Assessing and Communicating Risk: A Partnership to Evaluate a Superfund Site on Leech Lake Tribal Lands

Groundwater Panel Report

Groundwater Panel Report

FIGURE 1

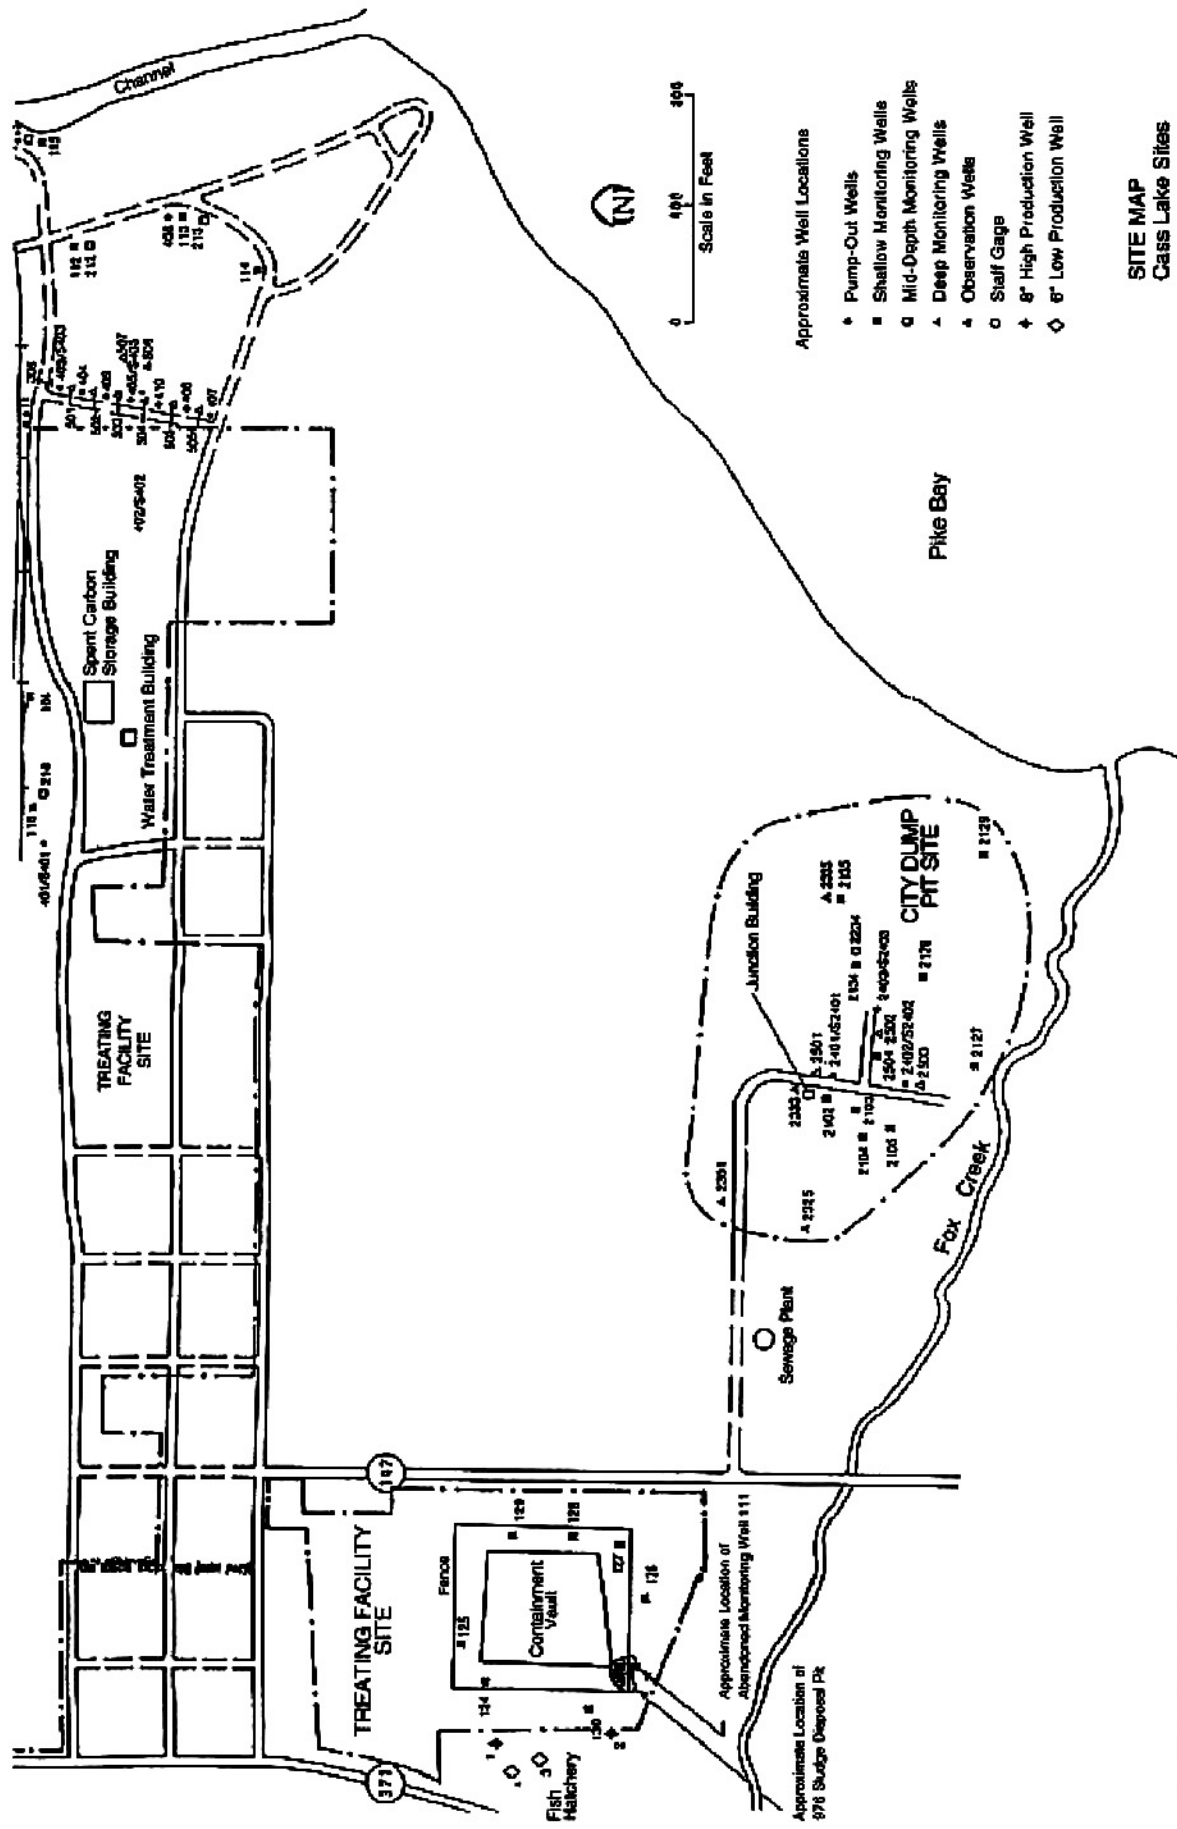
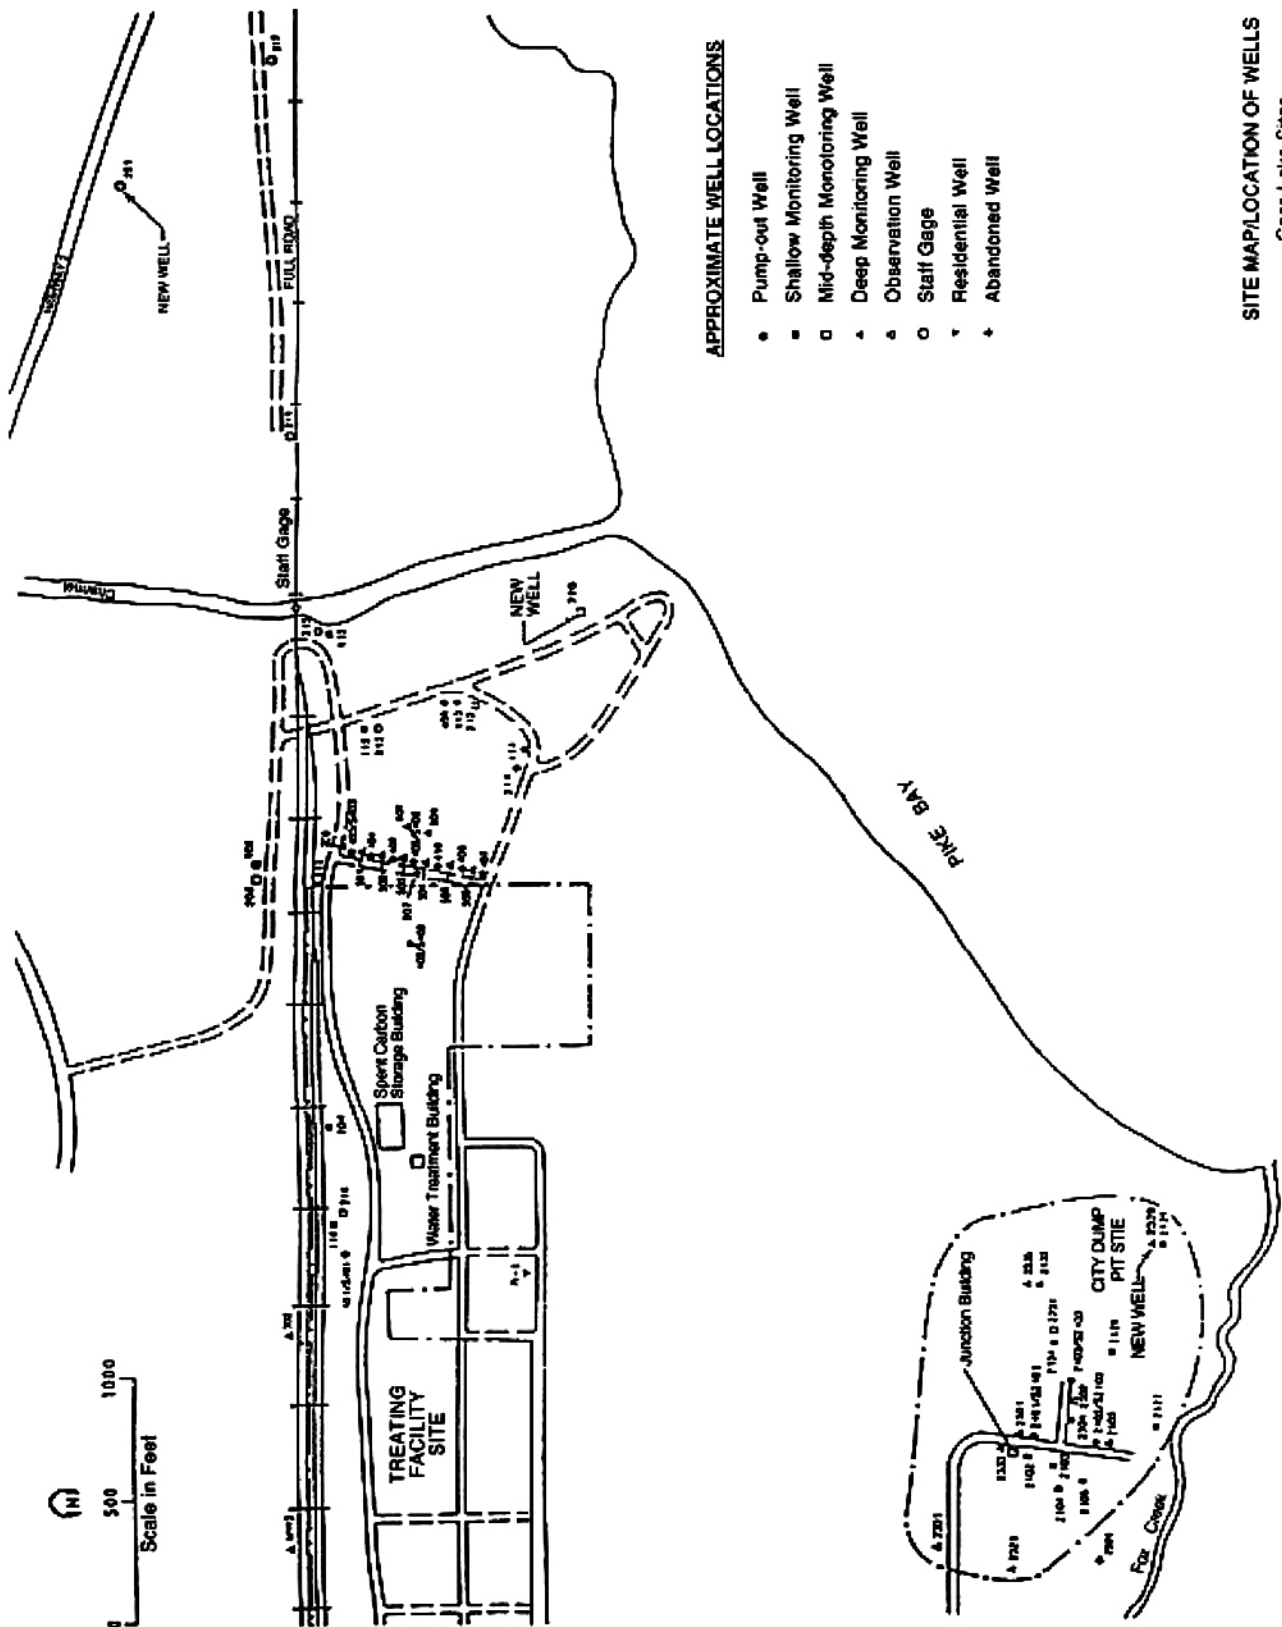
Groundwater was contaminated by the operation of a wood preserving business located on the Leech Lake Chippewa Tribal Lands in the city of Cass Lake in the Chippewa National Forest. It is bounded on the north by Burlington Northern and Soo Line Railroads, and on the west by Minnesota Highway 371 (Fig. 1). The surface waters drain to Pike Bay and the channel that flows from Pike Bay to Cass Lake. These waters then empty into the headwater area of the Mississippi River. Groundwater flow in the area is generally from west to east.
